Revised Environmental Assessment
(EA)

PROPOSED SOCIAL WELFARE FACILITIES (RESIDENTIAL CARE HOME FOR THE DISABILITIES (RCHD)) IN “VILLAGE TYPE DEVELOPMENT” ZONE, VARIOUS LOTS IN D.D. 104 AND ADJOINING GOVERNMENT LAND, NAM SANG WAI, YUEN LONG

Report No.: RT25285-EA-02C

Modification Plans of Noise Barrier and Street Furniture

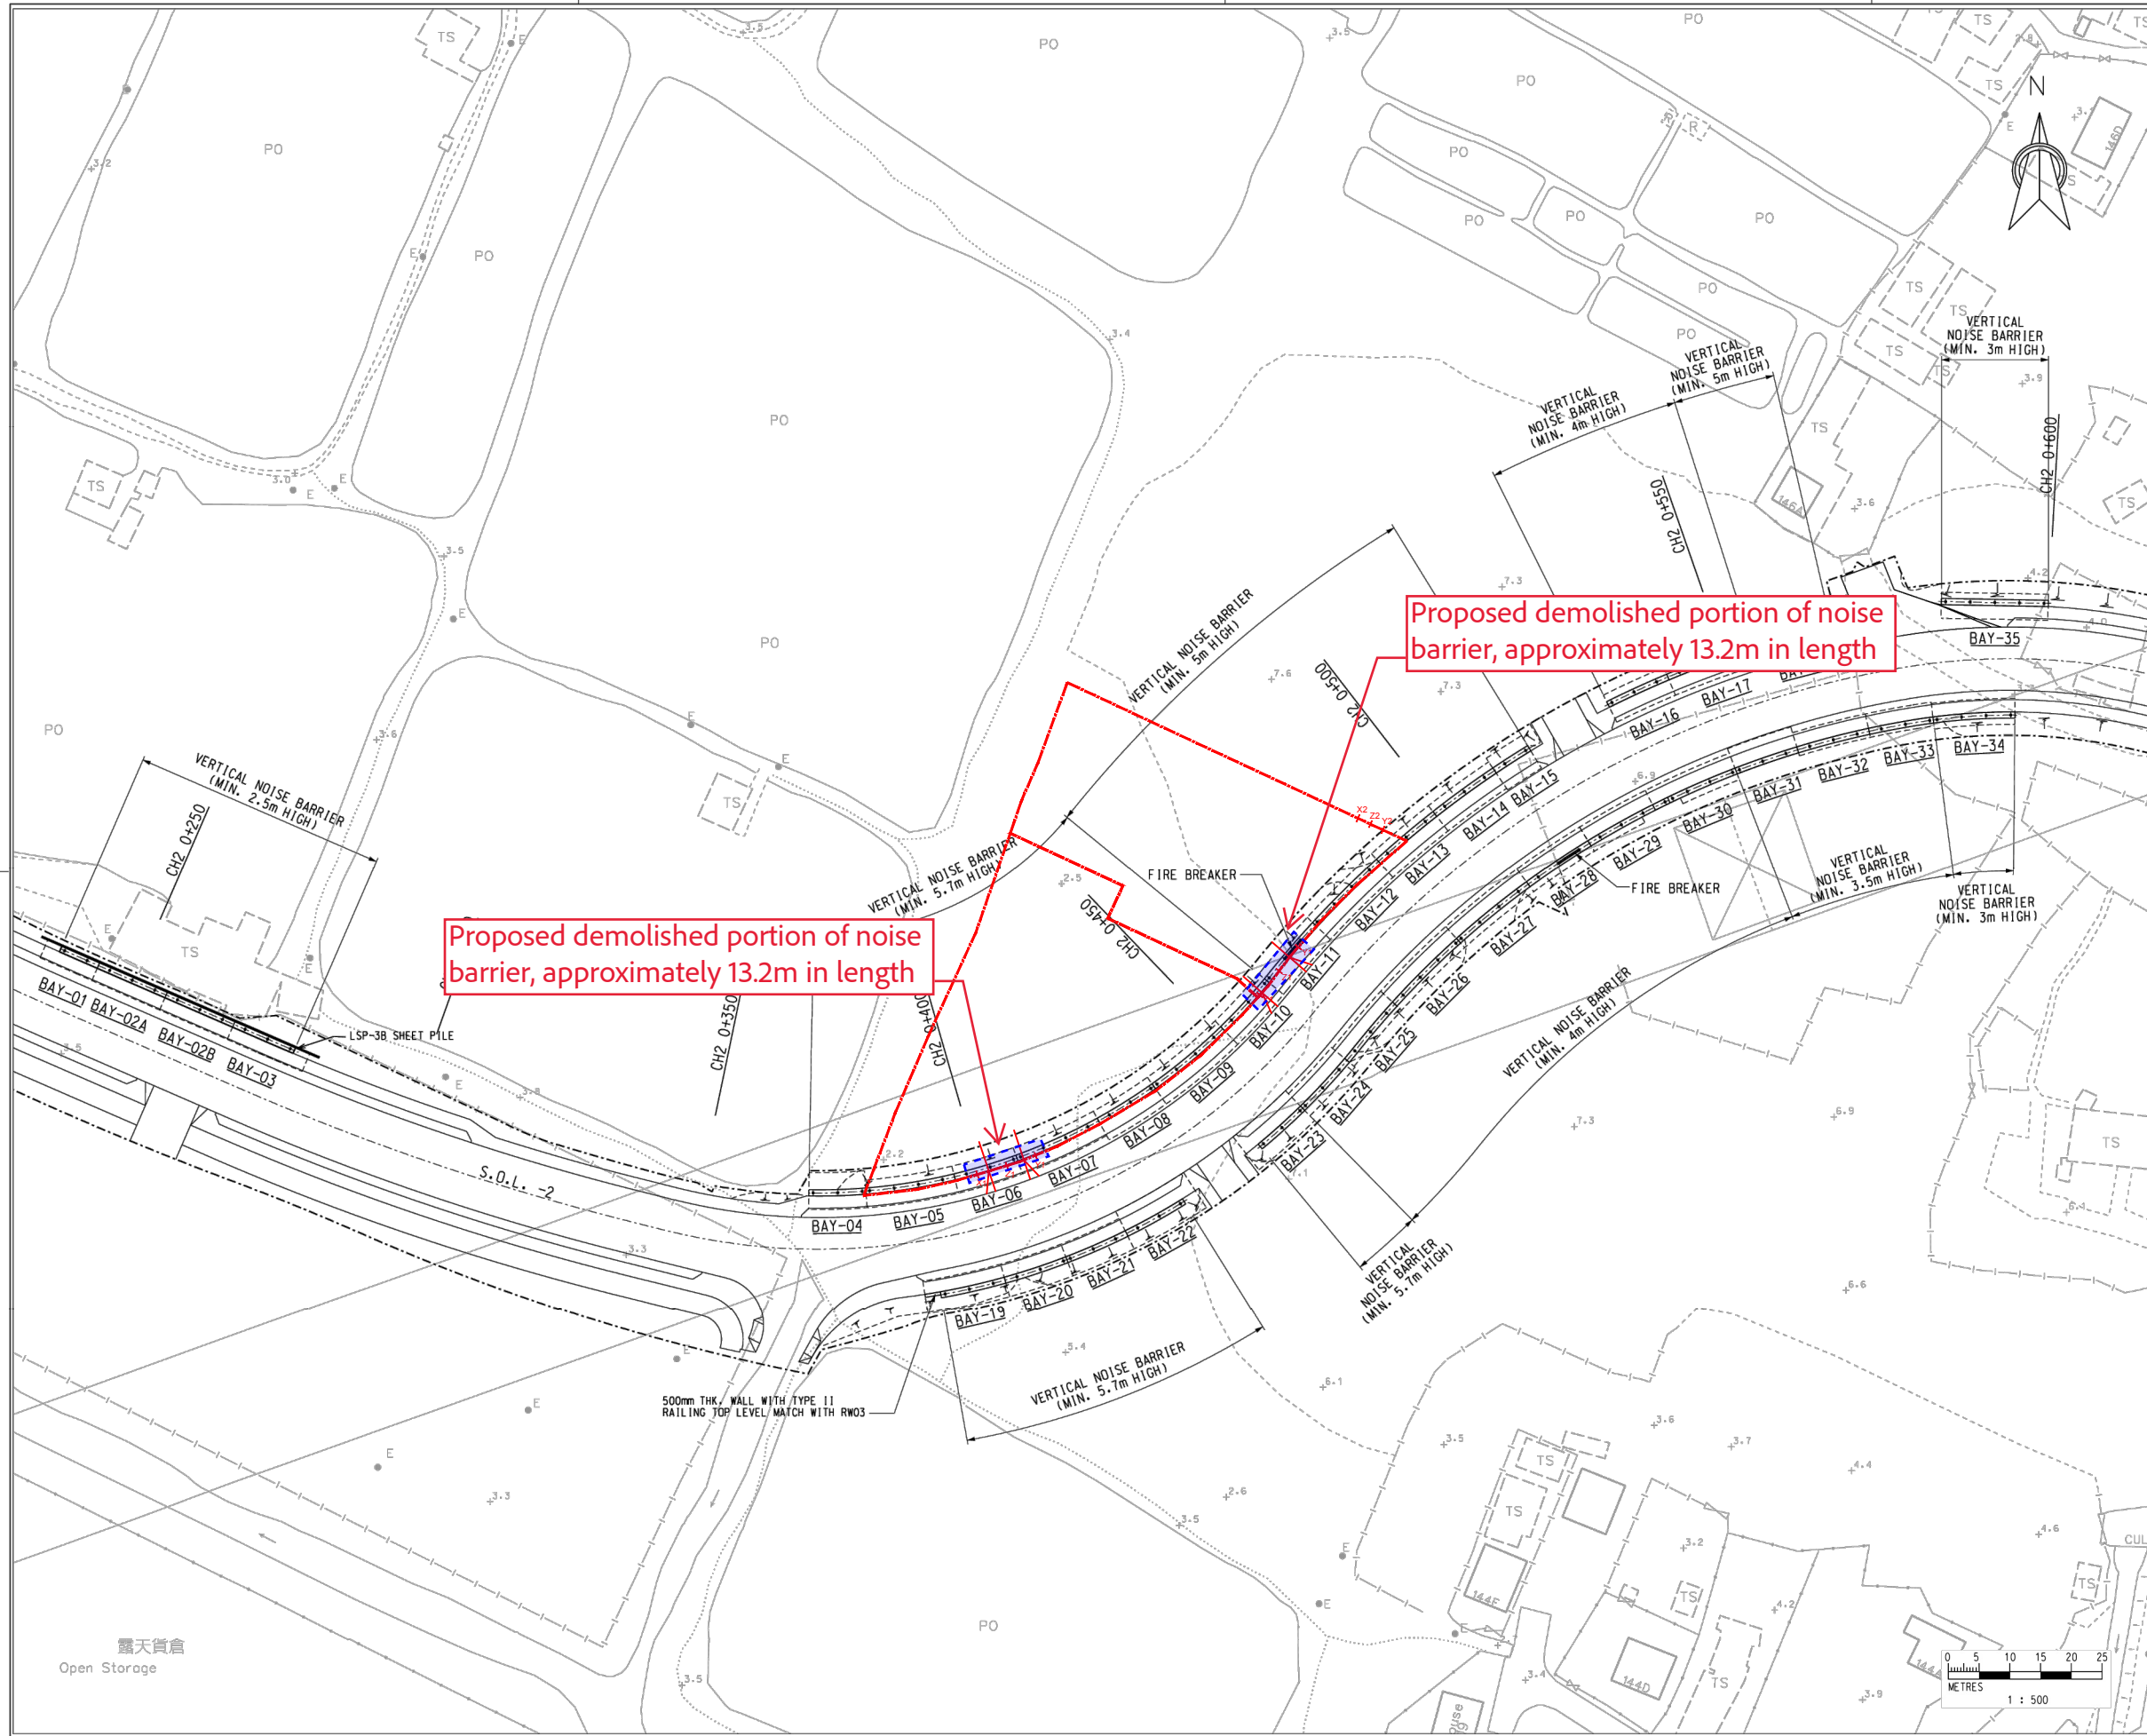
16. There are noise barriers positioned at the proposed site access. Please provide details on the site access arrangement;	Portion of the existing noise barriers and related street furniture (planter) will be demolished for the proposed site access. Please refer to Appendix 3 for the proposed alterations.
